BCA Assessment Report

Triple Two Nine Industrial Development
13 Endeavour Road, Caringbah

Revision 3.1

Reference: 230188

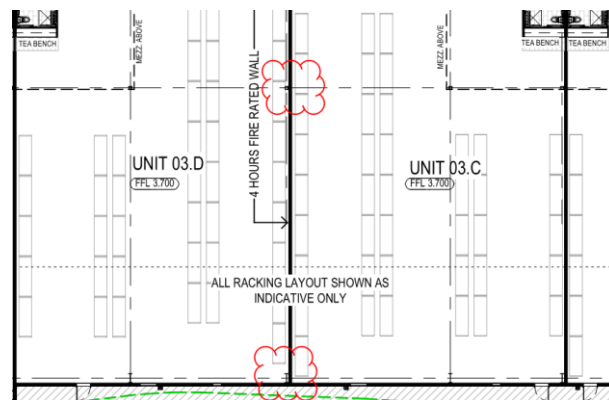
Comment: Spandrel protection is not required where sprinkler systems are provided. Noting that it is understood that the buildings are all required to be sprinkler protected, the requirements of this clause are not applicable.

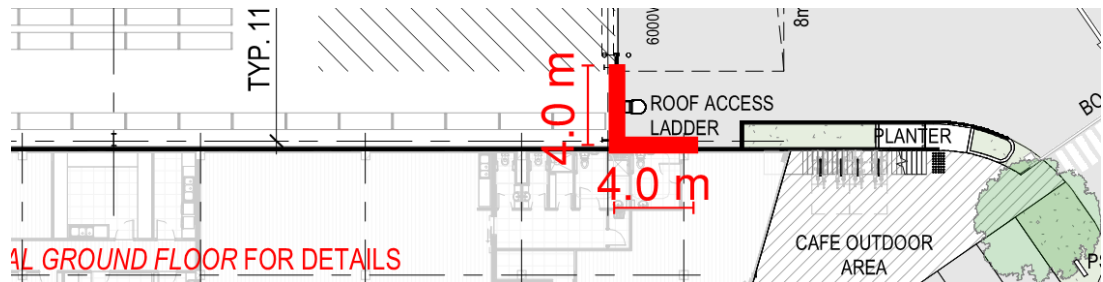
The below exposure occurs in Building 5 (Block 1). These walls require a 60/60/60 FRL & openings appropriately fire protected also.

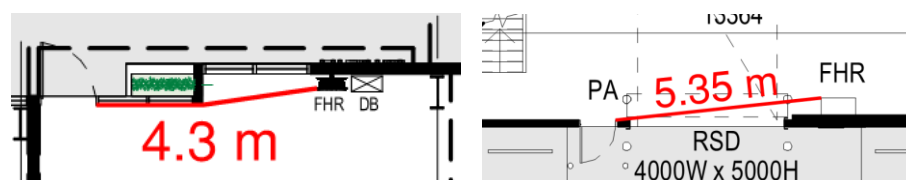
The provided plans show multiple FHRs located greater than 4m from an exit, which does not comply with E1D3. Plans demonstrating compliance are to be provided as part of the relevant CC application(s). See below examples in Building 3 Unit 03.B (left) & Building 4 Unit 04.7 (right).
